# Indiantown Cogeneration, L.P.

April 7, 1997

RE: Indiantown Generating Plant  
Permit Nos.: PSD-FL-168 & PA 90-31

FIG. 1  
BAG TENSION INSTRUCTIONS

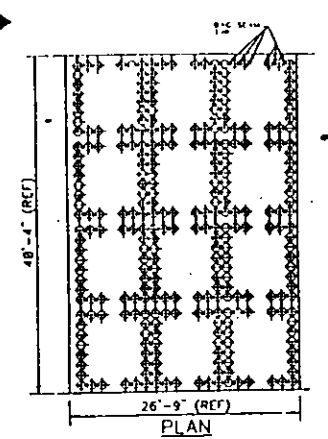
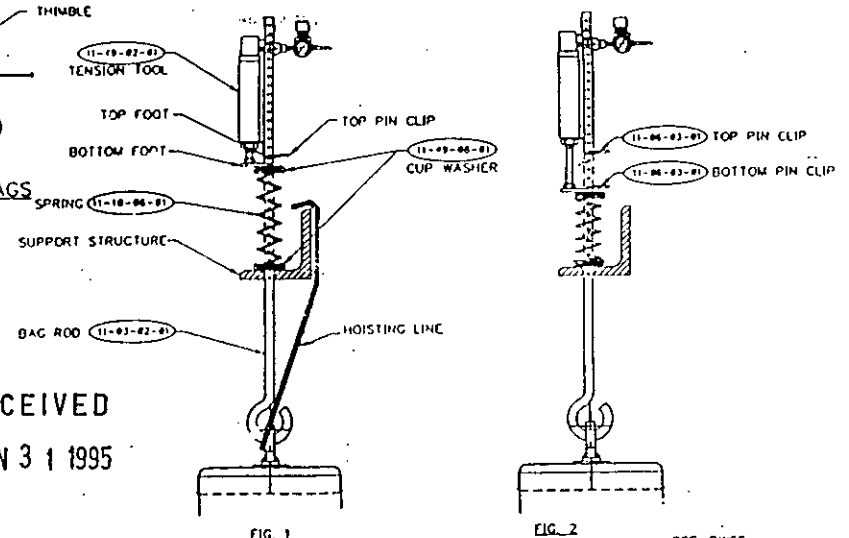
1. ***What methods did ICLP use to assure that the clamps were installed properly and that workmanship did not contribute to the failure?***

**Response:** During the outage ICLP used approximately 20 different individuals from the Maintenance and Operating departments to accomplish the work. These employees were directly supervised by one of the plant's Shift Supervisors assigned to manage that particular job. All the supervisors had reviewed the ABB instructions on the proper installation of the bag clamp and the tensioning of the bag. Most of the individuals installing the bag clamps were involved during the plant's October outage when all 12 compartments were individually re-tensioned with no subsequent failures of the clamp. Therefore, we felt these individuals were very familiar with the process of removing, setting and re-tensioning the bag and clamp assembly. (See attachment 1- ABB installation instructions). ICLP personnel used the following procedure to complete the clamp replacement process.

- a) The bag clamps were all loosened and removed in a individual compartment.
- b) The new stainless steel clamps were put on the collar of the bag and then positioned on the thimble of the lower plenum.

- c) The individual at the bottom of the bag then used an electric screw driver to tighten the clamp until the entire assembly was tight enough to position next to the locking collar of the thimble.

- d) The individual at the top of the bag placed the tensioning device in position on the bag spring and removed the lower locking pin on the tensioning assembly.

- e) Using ( 110 - 115 psig) plant air a pressure of 54 pounds is applied to the tensioning device resulting in a force of 75 psi to the spring of the tensioning assembly.

- f) The individual at the top of the filter assembly then radios the individual at the lower end of the assemble to check the position and do the final tightening of the clamp.

- g) Once this is complete the lower retaining clip is replaced on the tensioning assembly and the air is bled from the tensioning device.
- h) After the work on a section was complete the area was inspected.
